Stage 1 Road Safety Audit Designer's Response

Report Title:	Stage 1 Road Safety Audit Designer's Response – Proposed Site Access, Hemingfield Road, Hemingfield
Date:	21 st August 2024
Document Reference and Revision:	23-160-006.03
Prepared by:	Bryan G Hall Limited
On behalf of:	Barnsley Metropolitan Borough Council (Overseeing Organisation)

Title: Proposed Access Arrangement - Right Turn Ghost Island Junction

Drawing No:	23/160/ATR/003	Revision:	A
Job No:	23-160	Date:	02.08.2024

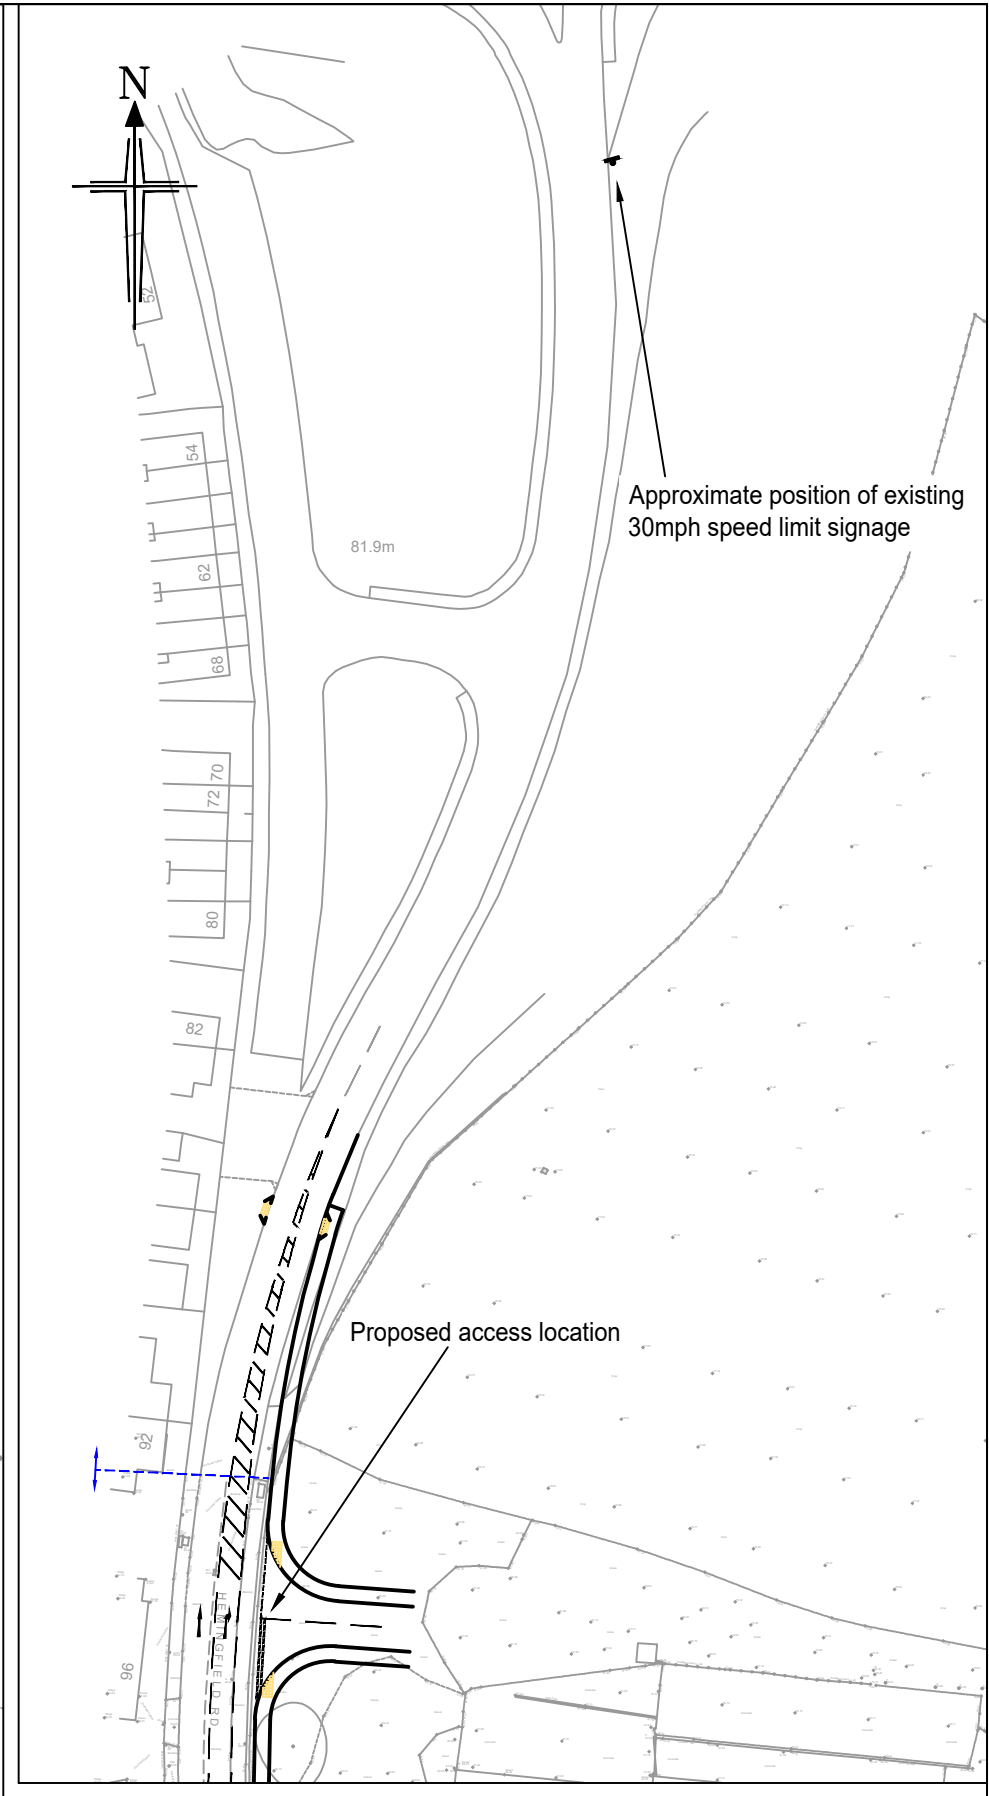
Problem H				
Hemingfield Road southbound through lane width.	It is recommended the southbound movement through the junction is assessed further to ensure that large vehicles including buses can pass through	Swept path analysis of a single deck bus and a 16.5 metre articulated HGV travelling southbound along Hemingfield Road has been undertaken, as shown on drawing number 23/160/ATR/003 Rev A at Appendix BGH2 .

RSA Problem	RSA Recommendation	Design Organisation Response	Overseeing Organisation Response	Agreed RSA Action
	the junction safely without encroaching on the right turn pocket associated with the proposed access.	<p>BMBC have requested that a 0.5 metre clearance from the kerb line is provided for swept path analysis, therefore this has been reflected.</p> <p>The swept path analysis shows that both vehicles can pass southbound through the proposed junction without encroaching into the area of the right turn ghost island where vehicles may be waiting to turn right into the site. Whilst there is a very slight encroachment into the entry side of the ghost island, this is exaggerated by the 0.5 metre kerb clearance shown on the swept paths, as in reality, vehicles would be travelling more centrally within the southbound lane.</p> <p>Full height kerbs will be provided along Hemingfield Road, in the vicinity of the site access to provide added protection for pedestrians along the footway.</p>

Drawing No: 23/160/SKH/007
Job No: 23-160
Revision: E
Date: 13.10.23

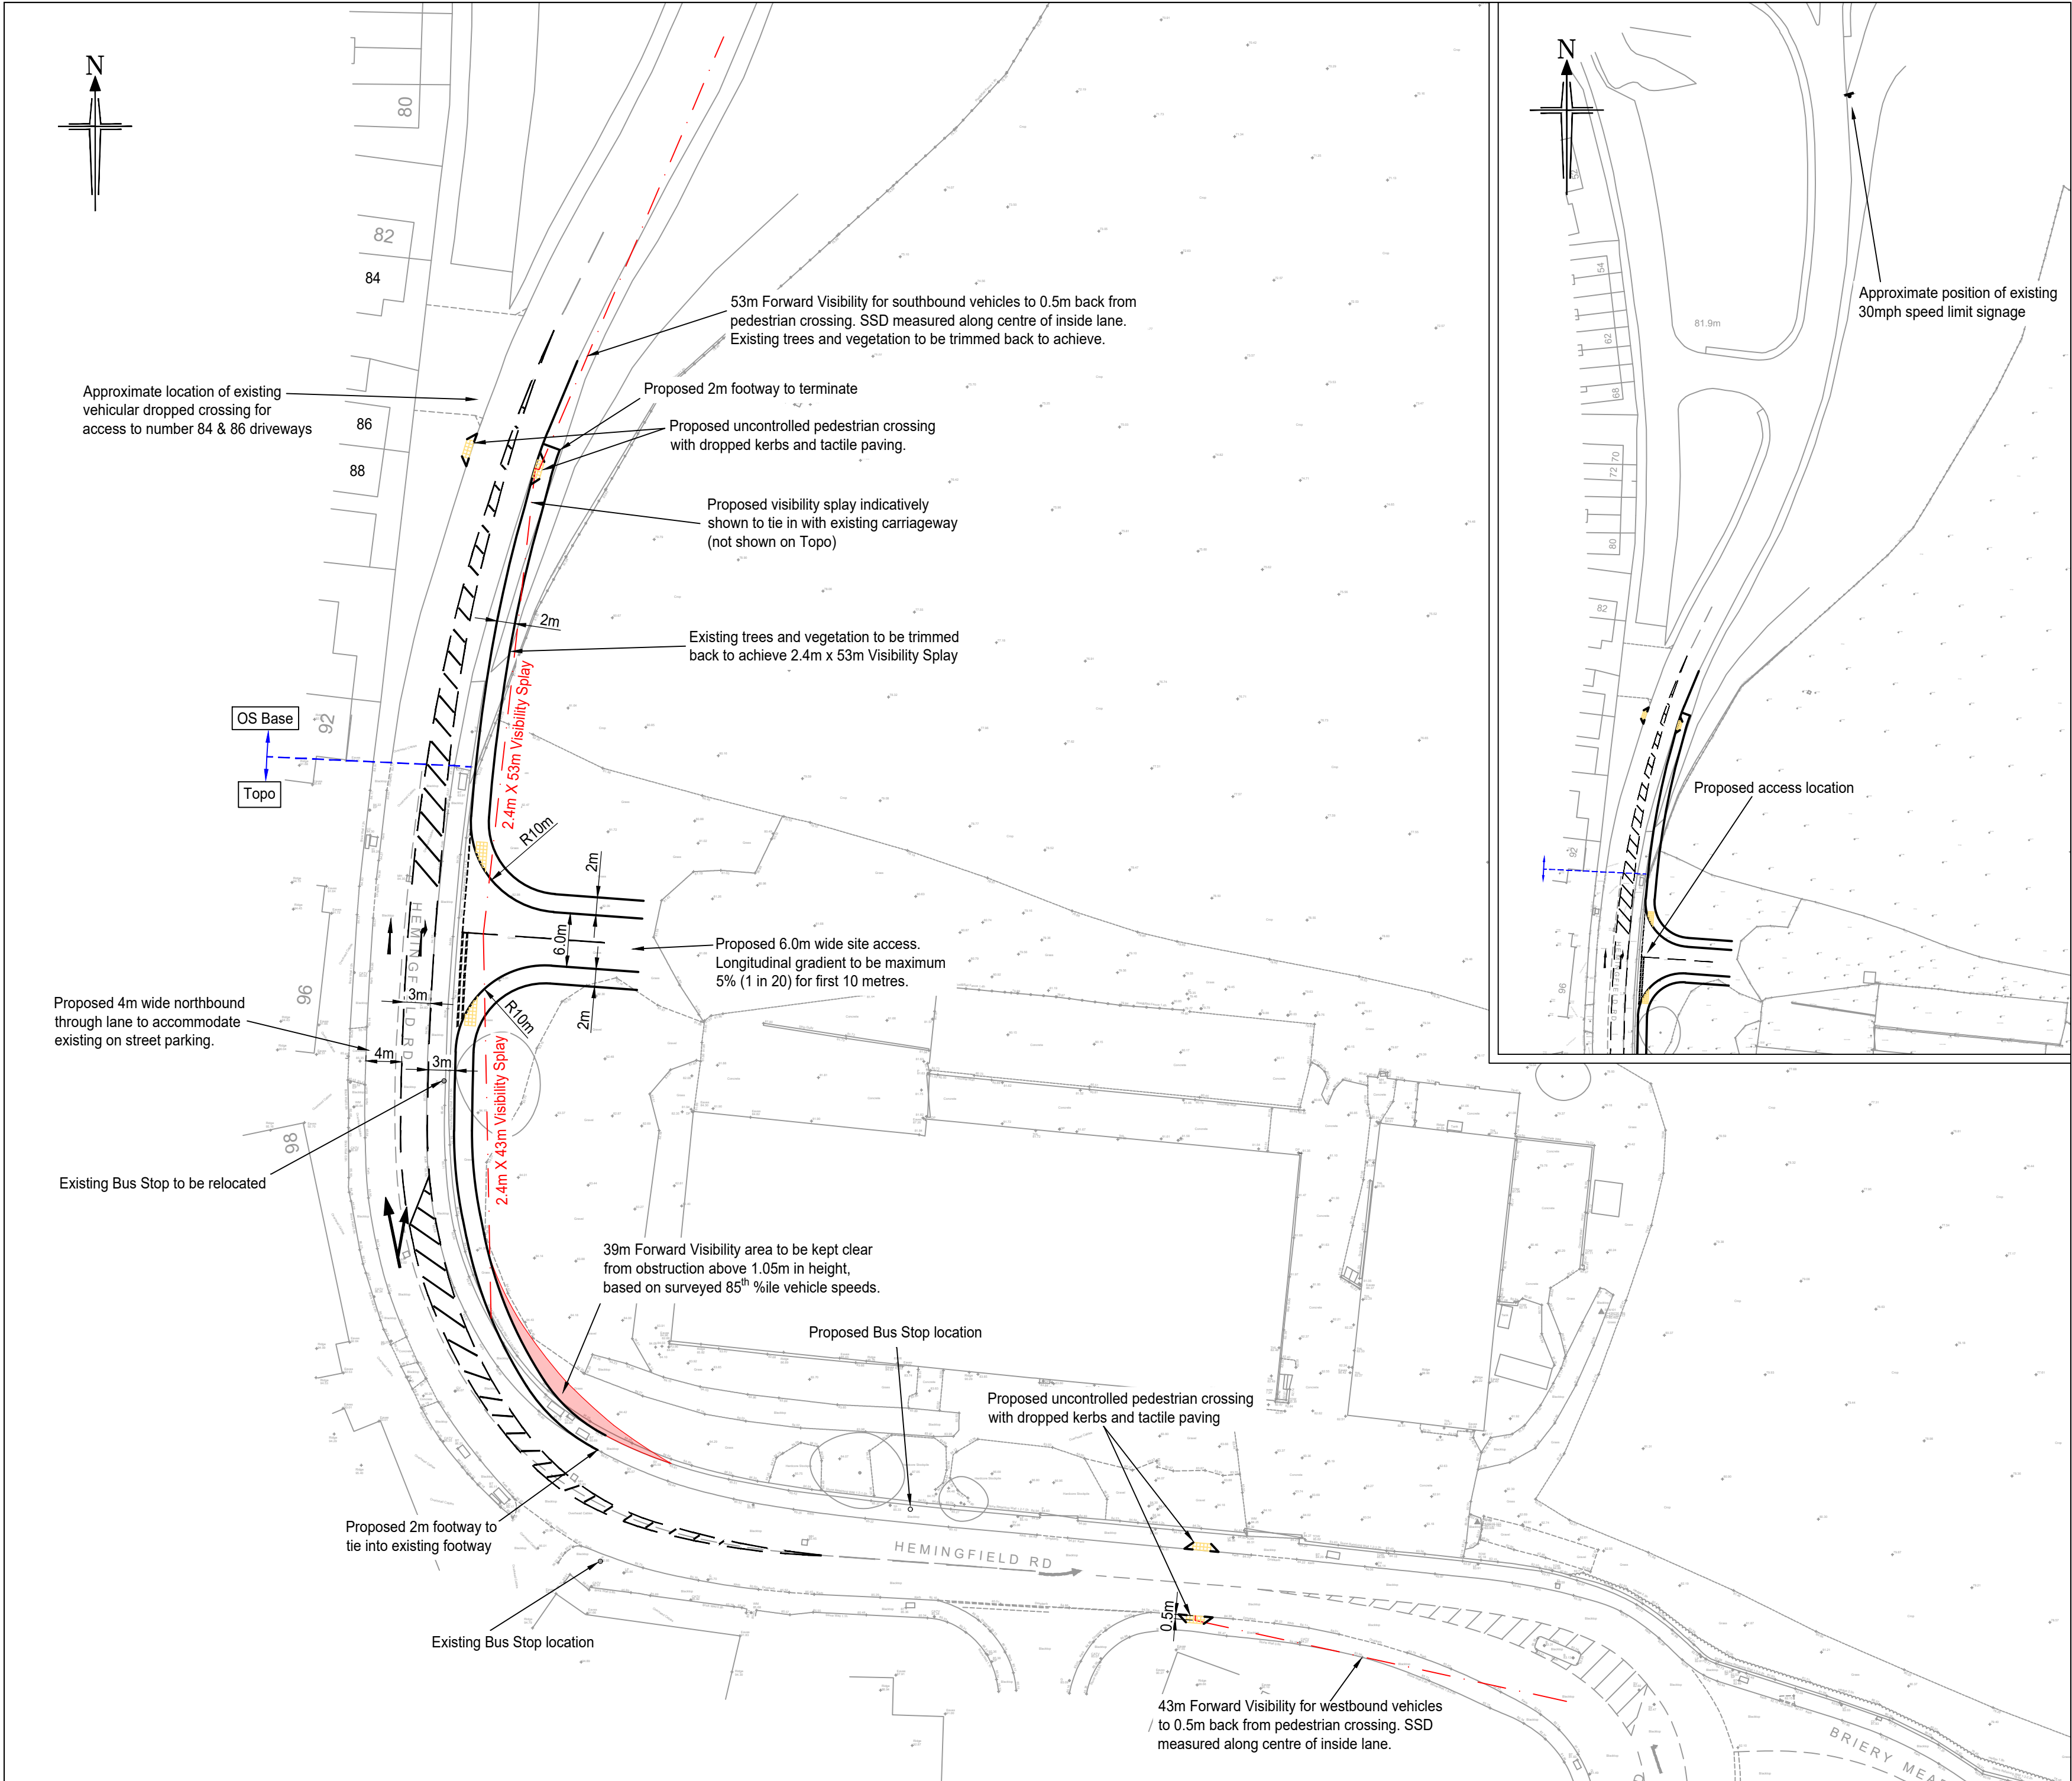
RSA Problem	RSA Recommendation	Design Organisation Response	Overseeing Organisation Response	Agreed RSA Action
Problem A				
Parking on western side of Hemingfield Road opposite the proposed site access.	It is recommended that measures to ensure that parking does not restrict carriageway width opposite the proposed side road are provided.	<p>Paragraph 5.9 of the Transport Assessment (document ref. 23-160-001.03) sets out that a 4 metre wide northbound through lane is proposed to accommodate the existing on street parking on Hemingfield Road in the vicinity of the proposed site access junction. This, alongside the provision of the 3 metre wide right turn ghost island means that traffic can continue to flow while vehicles are waiting to turn right into the site.</p> <p>Should vehicles be parked fully within the carriageway, this would require 2 metres of carriageway width, in line with the guidance in Figure 8.18 of Manual for Streets for parallel parking spaces. When combined with the proposed 3 metre wide right turn ghost island, there would therefore be an available width of around 5 metres for a car waiting to turn right into the site and a northbound car to pass through. It has been observed on site that vehicles currently park partially on the footway, therefore the available width may even be more than 5 metres.</p> <p>Figure 7.1 of Manual for Streets indicates that a minimum carriageway width of 4.1 metres is wide enough for two cars to pass each other, therefore a width of 5 metres is considered to be appropriate to accommodate a car waiting to turn right and a northbound car passing through.</p> <p>Figure 7.1 of Manual for Streets indicates that a minimum carriageway width of 4.8 metres is wide enough for a car and a larger rigid vehicle to pass each other. Therefore it may also be possible for a northbound refuse vehicle or a bus to pass a car waiting to turn right into the site. If not,</p>

Problem C				
Footway provision on Hemingfield Road to the north of the proposed access.	It is recommended that tactile paving and dropped kerbs are provided at a suitable location to the north of the proposed access and that appropriate intervisibility is provided between the crossing location and oncoming vehicles.	<p>The proposed site access drawing has been amended to extend the proposed footway on the eastern side of the carriageway to the north for around 45 metres. An uncontrolled pedestrian crossing point with dropped kerbs and tactile paving is then proposed to be located in the vicinity of numbers 86 and 88 Hemingfield Road, just to the south of the existing vehicular dropped crossing which provides access to the private driveways for number 84 and 86 Hemingfield Road.</p> <p>53 metres forward visibility will be provided for southbound vehicles on Hemingfield Road to see</p>

Problem E				
Proposed bus stop relocation location on Hemingfield Road.	It is recommended that forward visibility between drivers on the southbound carriageway of Hemingfield Road and the relocated bus stop is reviewed and measures are provided to ensure that the visibility envelope remains clear of obstruction.	<p>The exact location of the relocated bus stop is to be agreed with BMBC and the local public transport operators.</p> <p>Table 5.1 of the Transport Assessment shows that the surveyed 85th percentile speeds for eastbound vehicles in the vicinity of the relocated bus stop is 28.3mph, which equates to a 39 metre stopping sight distance. The proposed site access drawing has been amended to show a red hatched area within the site behind the proposed footway on the inside of the bend. The red hatched area will need to be kept clear from any obstruction above 1.05m in height, in order to provide 39 metres forward visibility around the bend and towards the relocated bus stop.</p>

The proposed site access drawing has been revised to address the comments raised by the audit team and is included at **Appendix BGH1** of this Designer's Response, along with an additional supporting swept path analysis drawing at **Appendix BGH2**, as detailed in this Designer's Response.

RSA Problem	RSA Recommendation	Design Organisation Response	Overseeing Organisation Response	Agreed RSA Action
		<p>then the northbound vehicle would simply need to wait briefly for the right turning car to clear. The modelling of the proposed site access junction shows that there would be minimal delays to vehicles turning right into the site of around 6/7 seconds and that queuing of more than 1 vehicle is not likely to occur, therefore this is not considered to be an issue.</p> <p>Furthermore, at present, it is apparent that vehicles may have to encroach into the opposing carriageway to pass the parked vehicles. Therefore, it is considered that the proposed site access arrangement represents an improvement over the existing situation.</p>		
Problem B				
Hemingfield Road southbound approach to the proposed site access.	Provide sufficient stopping sight distance on approach to the proposed new junction from the north.	<p>In response to Problem C, a footway is now proposed to the north of the access, which will necessitate the removal of some vegetation in this area. Any remaining vegetation within the adopted highway is to be trimmed back as necessary to achieve the 2.4 metres x 53 metres visibility splay to the north.</p> <p>A note has been added to the proposed site access drawing to clarify this.</p>

RSA Problem	RSA Recommendation	Design Organisation Response	Overseeing Organisation Response	Agreed RSA Action
		<p>pedestrians on the eastern side of the crossing at a point 0.5 metres back from the dropped kerb. The 53 metres stopping sight distance has been measured along the centre of the southbound carriageway. The existing trees and vegetation will be trimmed back as necessary to achieve this forward visibility.</p> <p>On the western side of the carriageway, the proposed crossing is located where existing dwellings have private driveways and some additional block paved space in front of the properties to park off the carriageway. Therefore crossing pedestrians are very unlikely to be masked by vehicles parked on Hemingfield Road.</p>		
Problem D				
Site access pedestrian crossing facilities	It is recommended that tactile paving and dropped kerbs are provided at a suitable location on the desire line across the minor arm of the proposed junction.	An uncontrolled pedestrian crossing with dropped kerbs and tactile paving will be provide at the proposed site access as suggested. The proposed site access has been amended to show this.

E	21.08.24	Client name updated	RD	MC/JP/MC
D	19.07.24	Amended in response to Stage 1 RSA	RD	MC/JP/MC
C	18.01.24	Visibility amended to ATC speeds	RD	MC/JP/MC
B	06.11.23	Title block updated following client comments	MIT	MC/JP/MC
Rev:	Date:	Amendment:	DRN	CHK
			APR
